SUPPLEMENTAL INSTRUCTION

PROJ.: **Dovercourt Phase 2**
PROJ. No.: **1713**
DATE: **January 22, 2019**
S.I. No. **S.I. - 010**

Revised Washroom Ceilings

INFORMATION BULLETIN

ASK-004 SCALE 1:50

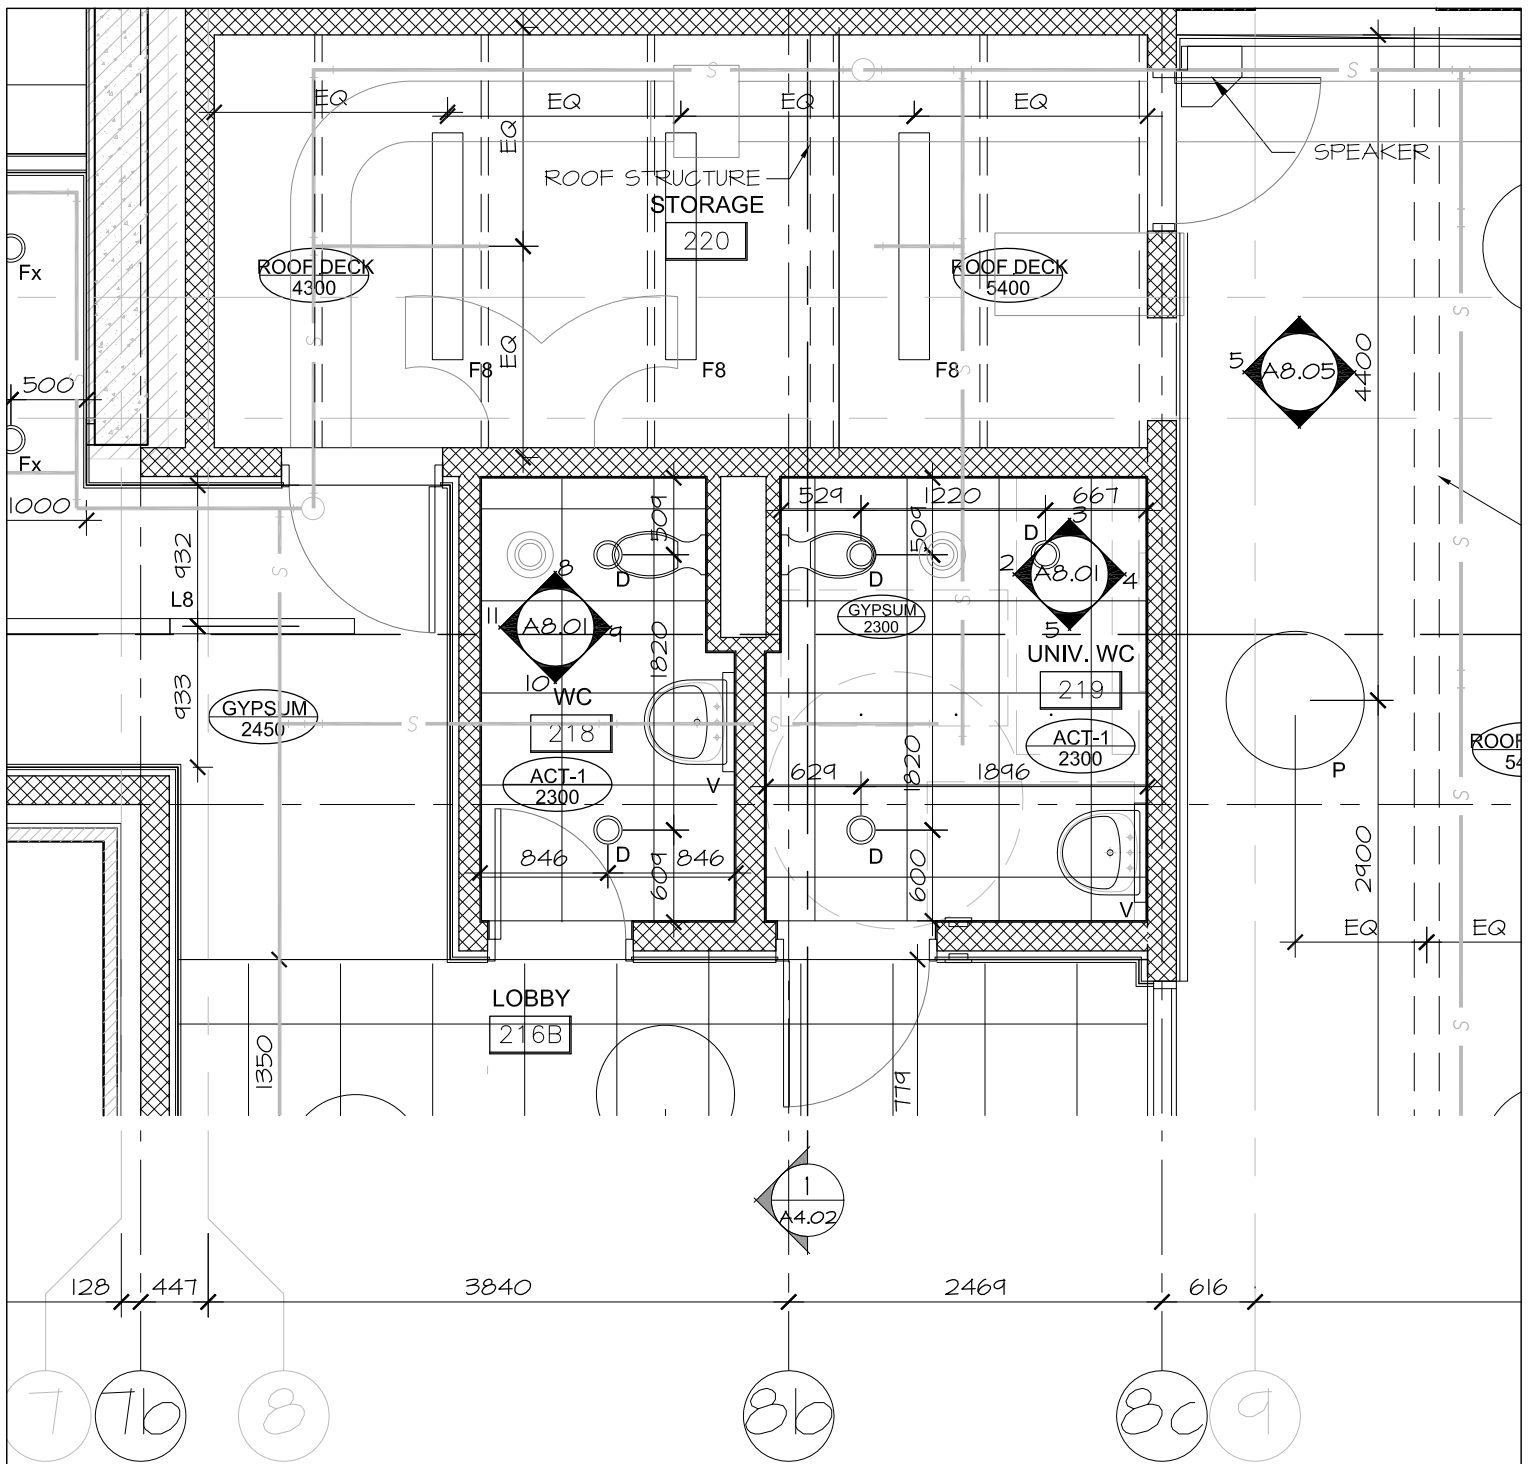
.1 Replace gypsum ceilings with suspended acoustic tile ceilings as per attached IB-A006

- .1 Delete Gypsum ceilings in washrooms
- .2 Provide ACT-1 ceilings as per attached ASK-004

To address the change in the washroom ceilings to be extend to the underside of the structural deck, thus creating a void space with no means of access. Addition of suspended acoustic ceilings will restore future access options.
